Re: Au Train - FERC Project No. 10856

SPILLWAY CAPACITY REMEDIATION – 60% DESIGN PACKAGE

Design Report Spillway Capacity Improvements

Subject: Response to Comments from FERC letter dated October 13, 2011
Au Train Hydroelectric Project; FERC Project No. 10856

FOR REVIEW ONLY
NOT FOR CONSTRUCTION
PROJECT: 10856
DRAWING NO: 14108-00-114919.01
DATE: DEC. 5, 2011
DESIGNED BY: NLH
DRAWN BY: DMS
CHECKED BY: JJB
SHEET CONTENTS:
AUXILIARY SPILLWAY
PLAN VIEW

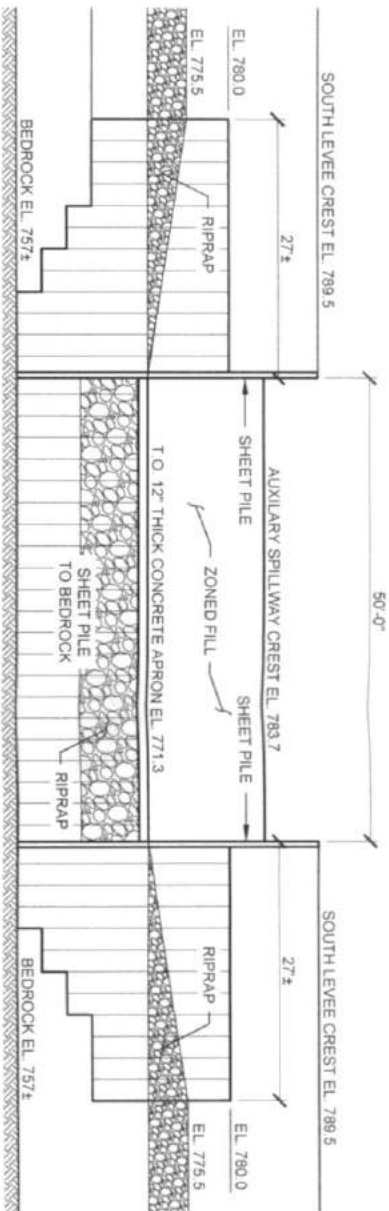
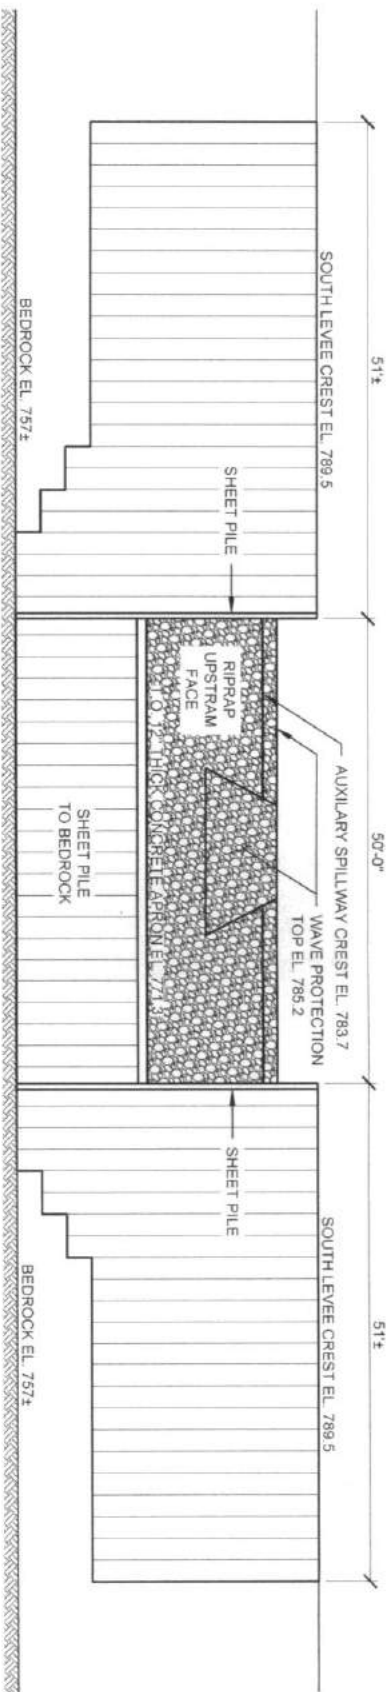
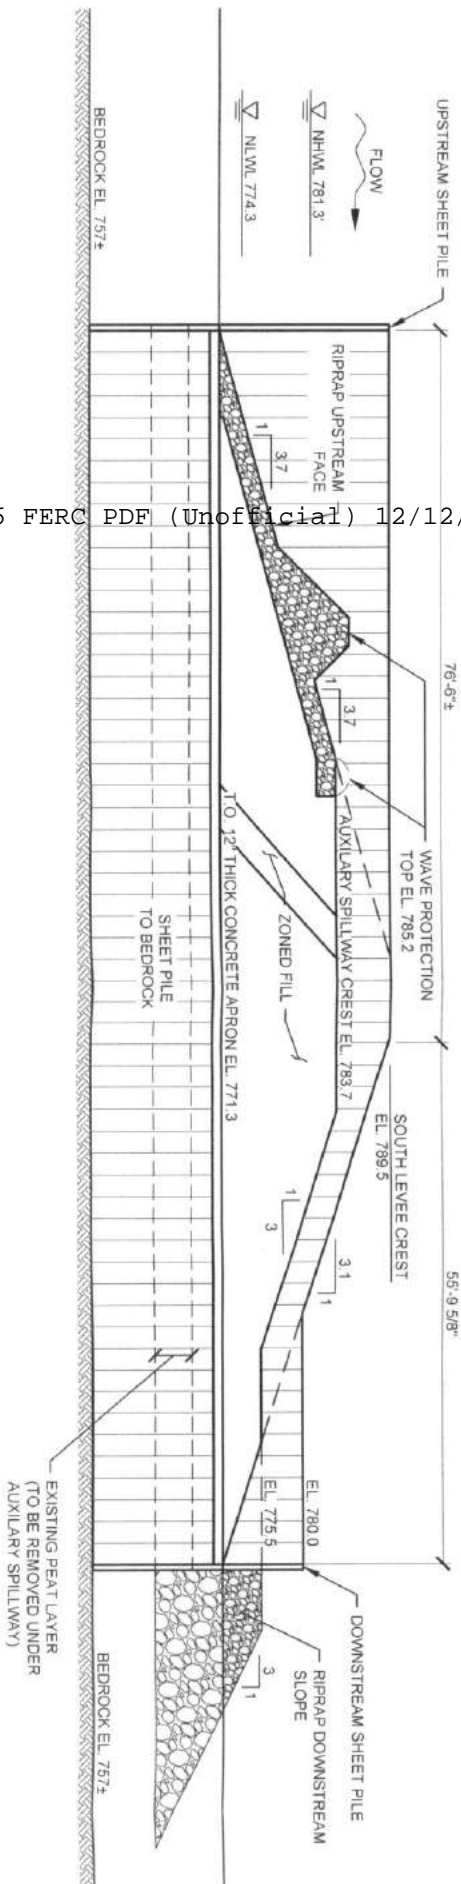
4. The conceptual design depends on riprap falling into specific locations to armor the wall of the fuse plug as it erodes. Since it would be next to impossible to ensure the riprap falls exactly where it is needed, this proposal is unacceptable. An alternative means of preventing lateral expansion of the fuse plug should be provided.

Sheet pile walls along the edges of the breach have been incorporated into this conceptual design to prevent its lateral expansion beyond the limits of the lowered levee section during erosion. The conceptual design drawings of the sheet pile walls are included in the *Design Report – Spillway Capacity Improvements (draft 60%)*, which is submitted with the letter.
